CASE

Subject: In the Matter of
Texas Utilities Generating Company, et al
Comanche Peak Steam Electric Station,
Units 1 and 2
Docket Nos. 50-445 and 50-446

Attachment to CASE's 6/7/84 Letter re:
Barriers to Settlement
On Design and Design QA Issues

SUBJECT: COMANCHE PEAK STEAM ELECTRIC STATION
CYGNA REVIEW QUESTIONS

Gibbs & Hill, Inc. Job No. 2323 Client TVGCO
 Subject RICHMOND INSERT CAPACITIES
 Calculation Number SCS - 228C SET #1 Sheet No. 12

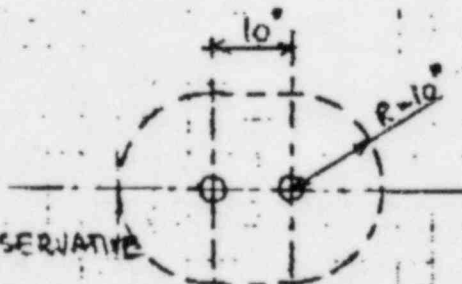
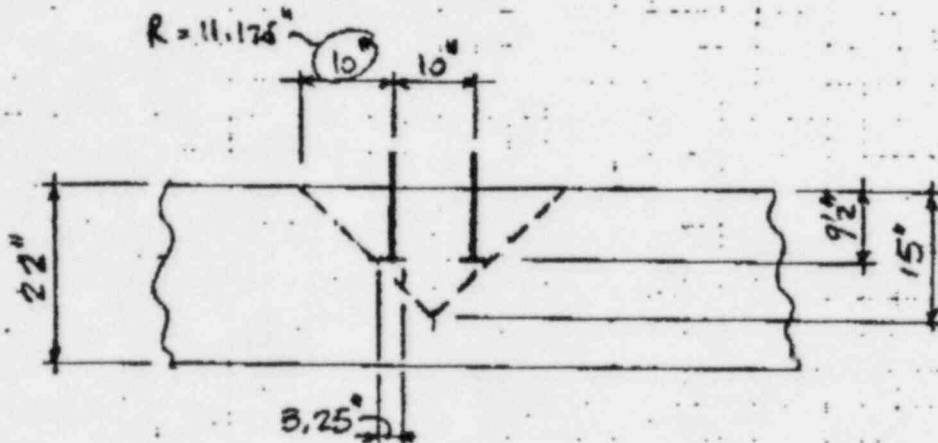
- i. How were the Tables in SS-30, Appendix 3, developed, since only a shear test was done?
- ii. How were the spacings determined?
- iii. How do the safety factors in SS-30 compare to those suggested by Richmond (3:1) for tension?

Aii. In those cases where Richmond Inserts have overlapping stress cones the allowables have been determined in accordance with Section B.4 of Appendix B - Steel Embedments, ACI-349.

See Attached sheets numbered 11, 12, and 13 for typical calculations.

1/2" φ INSERT SPACED AT 10" e/c BOTH WAYS

$$A_e = \left[\pi (10.0)^2 + 2 \times 10 \times 10 \right] - \frac{2\pi}{4} (3.25)^2 = 497.57 \text{ in}^2$$

$$P_d = 4 \times 0.65 \times \sqrt{4000} \times 497.57 = 81819.63^* \text{ FOR 2 INSERTS}$$

$$P_d = \frac{40909.8}{2} = 20454^* \text{ USE } 20.45 \text{ k}$$

G&H Job No: 2323 CLIENT: TUSJ
CALL No: 9RB150C, SET 1
SHEET No: 22
PREPARED BY: KUN DATE: 4-12-82
VERIFIED BY: DAP DATE: 4-16-82

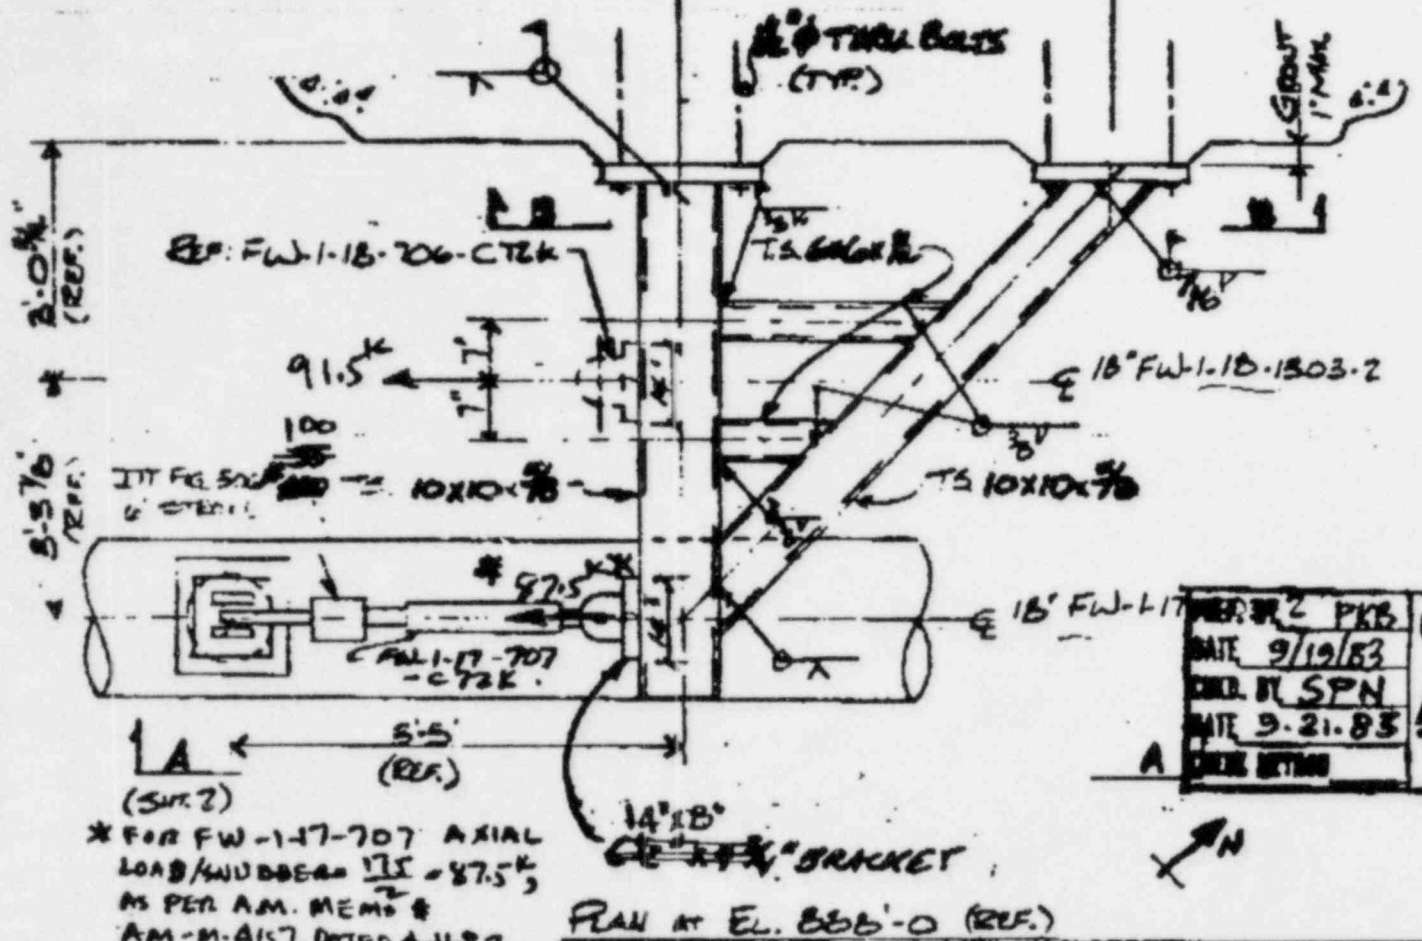
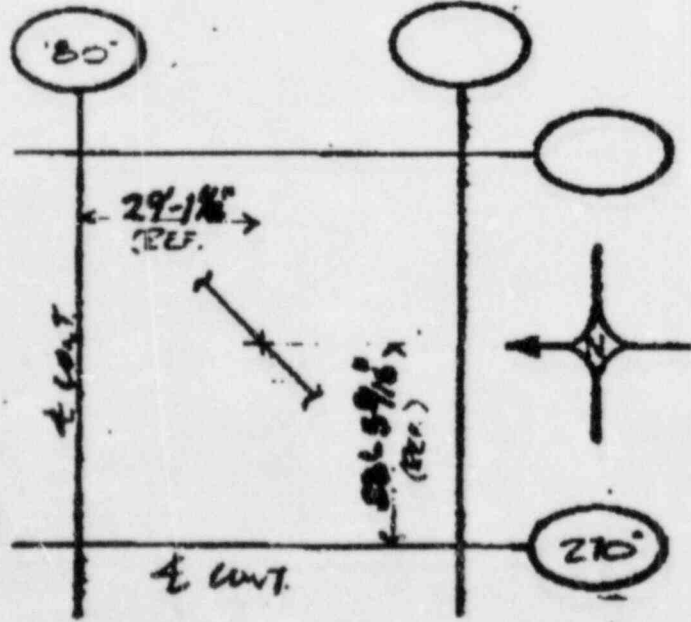
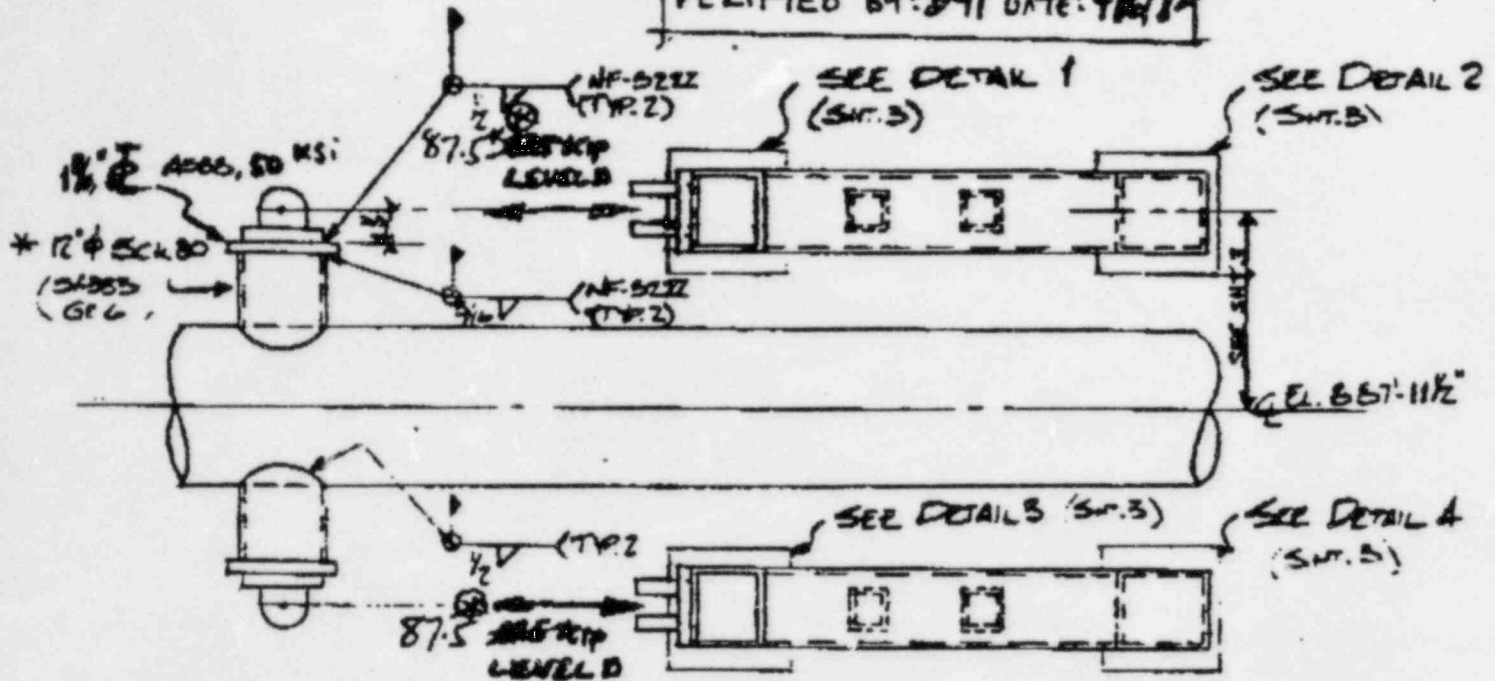
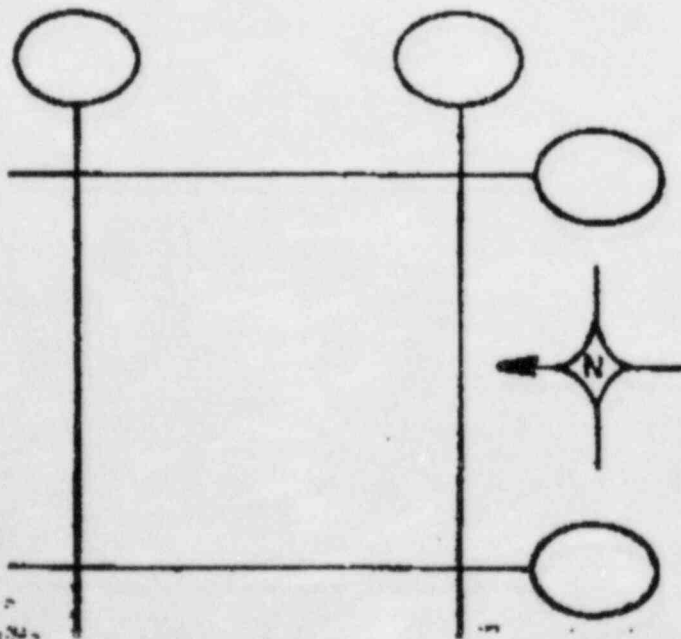
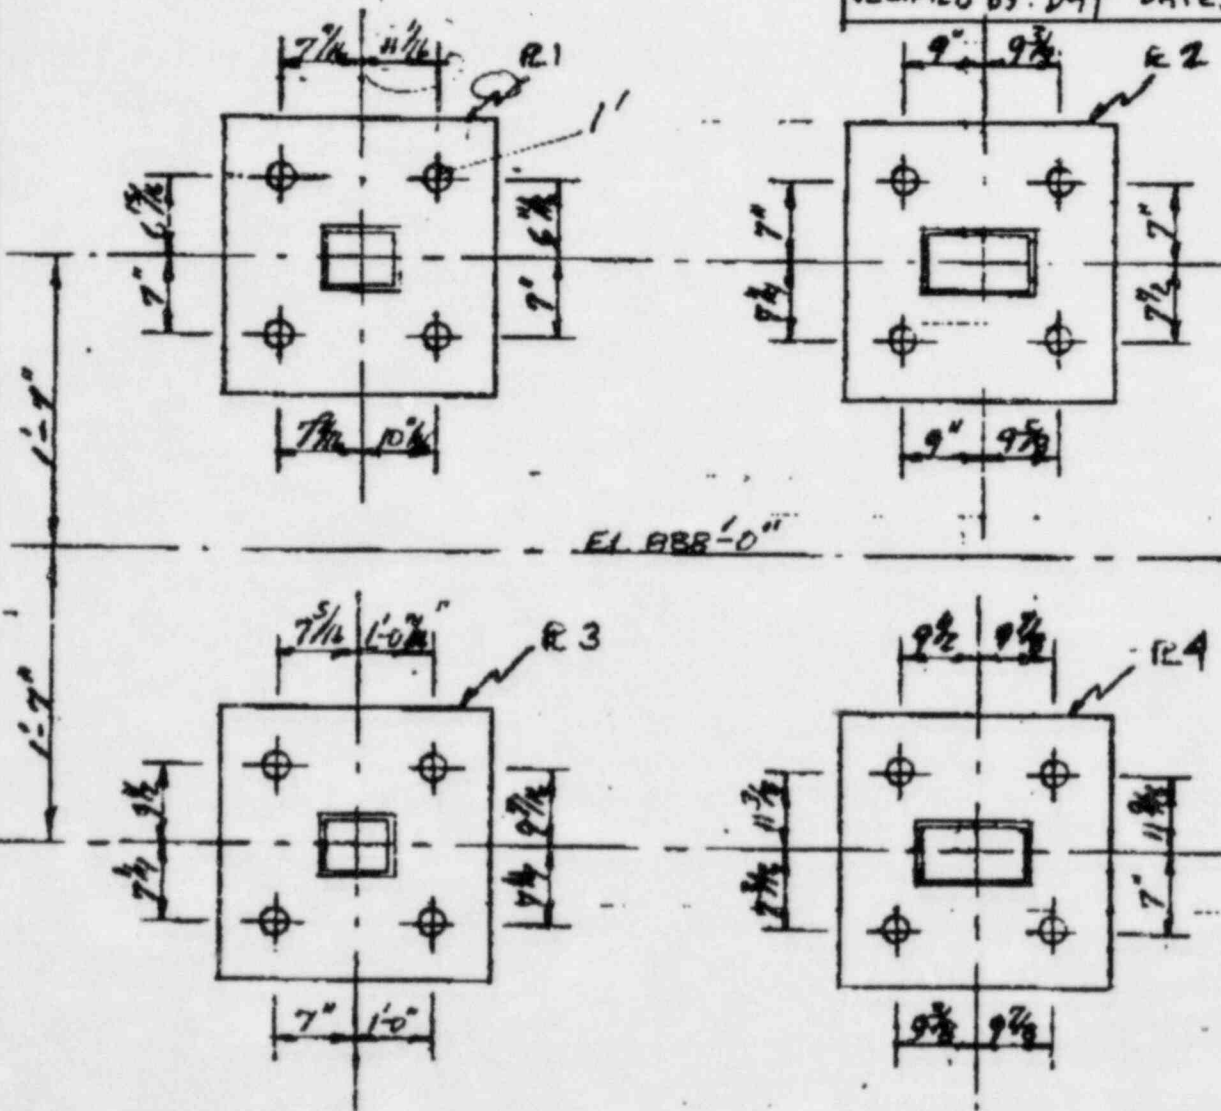
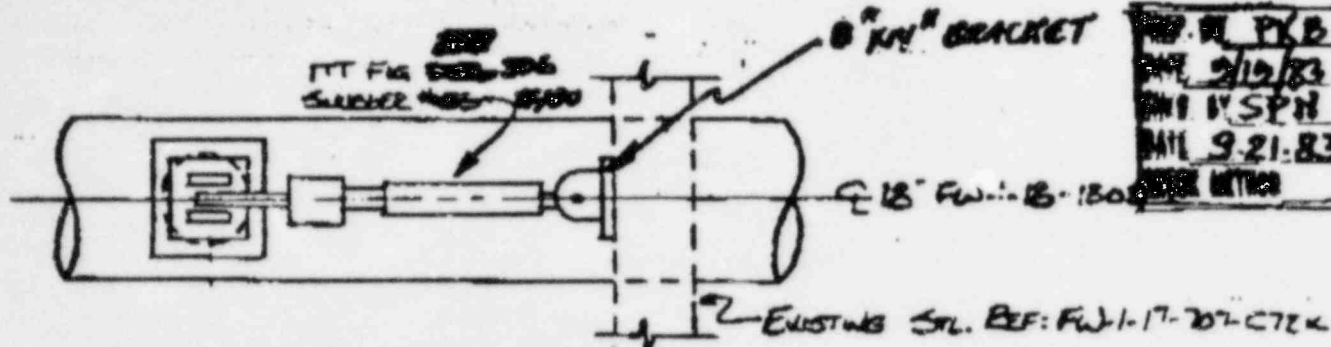
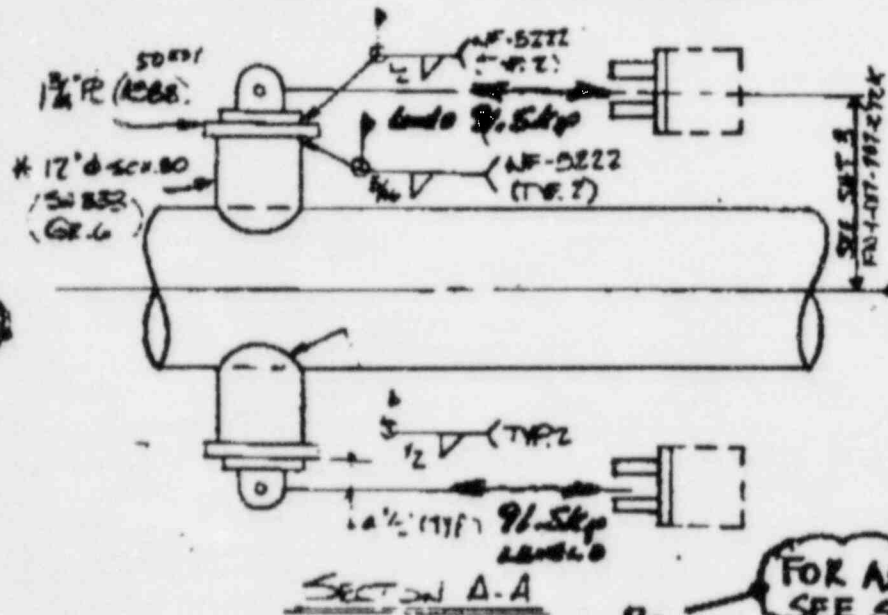
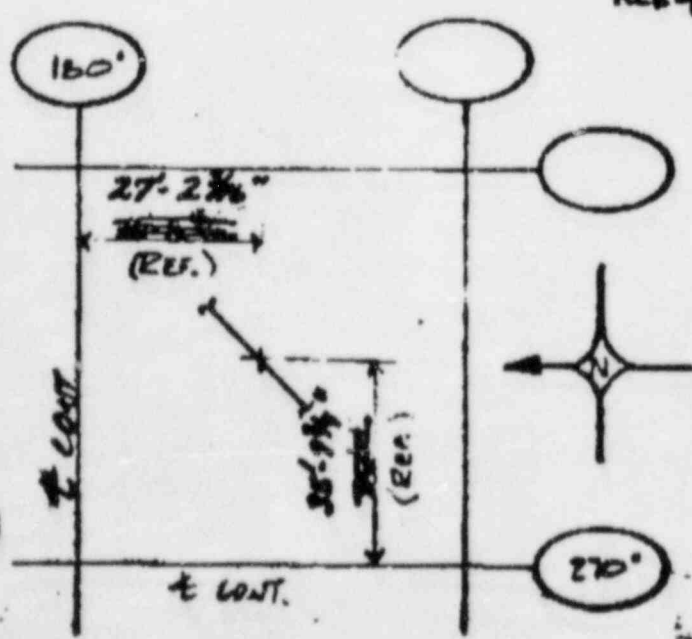
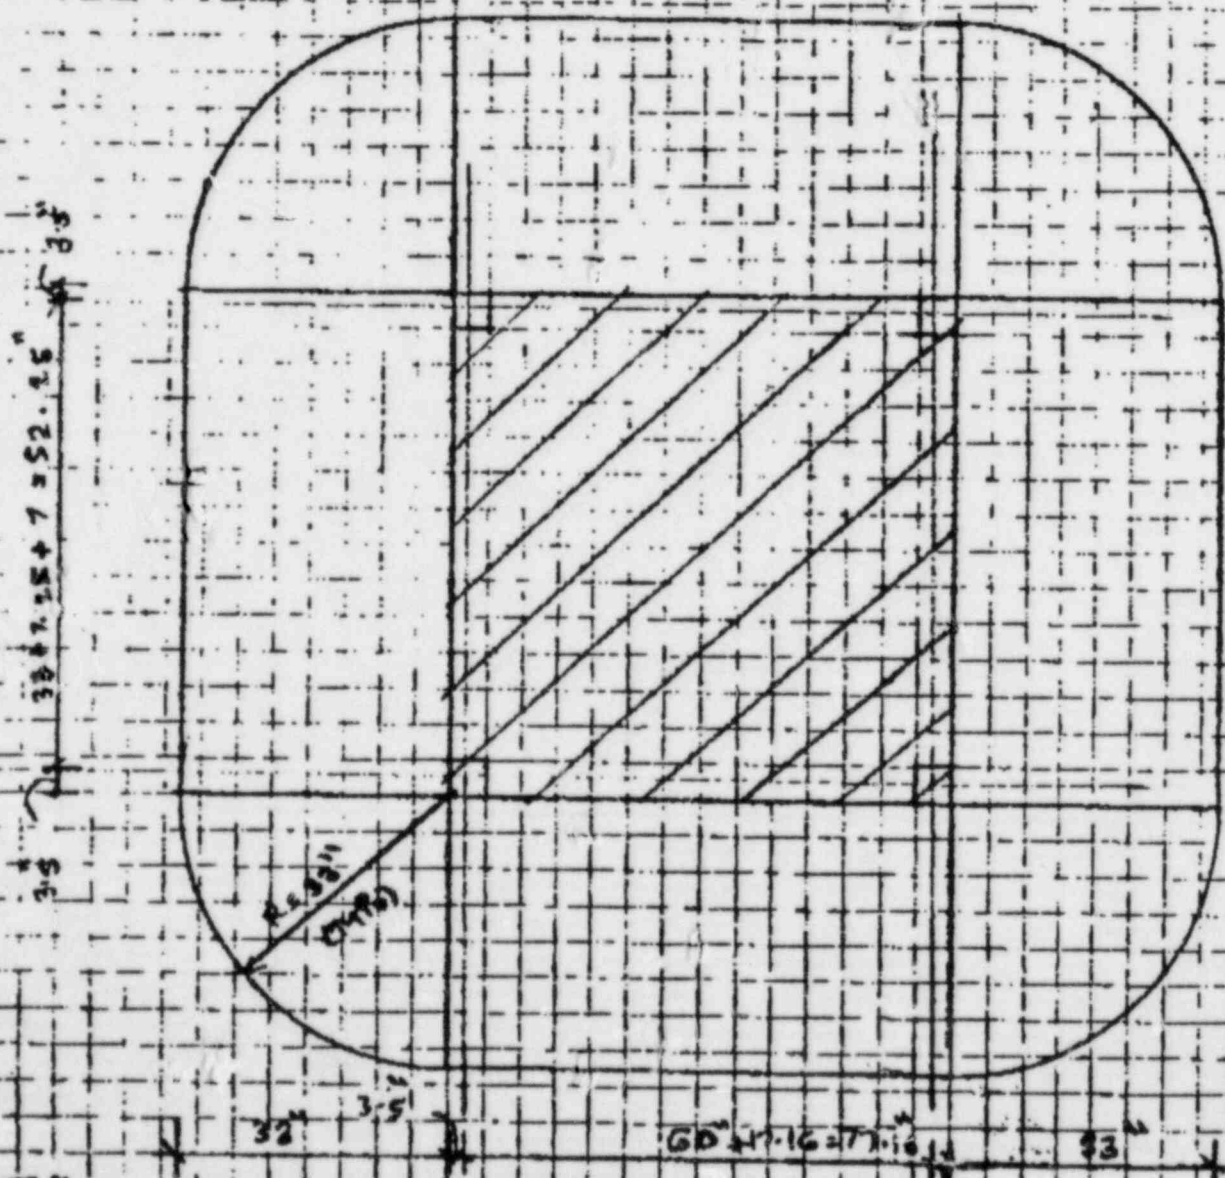
- 1B. In reviewing supports inside and outside containment, CYGNA has noted use of through bolts for certain cases (MS-1-002-001-S72R, for example). In each case, the bolts are checked against appropriate Code allowables.
- i. Who is responsible for checking the spacing between bolts, concrete edge distance and minimum thickness of concrete allowed?
 - ii. Who is responsible for checking the concrete element (possible local failure, shear, bearing)?
 - iii. Please provide documentation showing the above checks have been done by the responsible party.

The use of through bolts is employed on a case-by-case basis as required by the detail being designed. As such, Gibbs & Hill, the A/C, did not provide generic design criteria for their use. Gibbs & Hill has designed, reviewed, and approved their own use of through bolts in accordance with (i) and (ii) above.

For details concerning through bolts designed by other organizations (i.e., PSI, ITT, NPSI, etc.), Gibbs & Hill has or will be provided with loads and details to establish acceptability of the building structure. All through bolt designs will be reviewed specifically or generically to determine their acceptability prior to fuel loading. This was anticipated as part of the design course. Since (i) and (ii) above are a continuing action representative documentation of these design checks may be seen in attached calculation book SRB-15BC, Set 1, Sheets 22, 23, 24, 25 and 33 through 38.
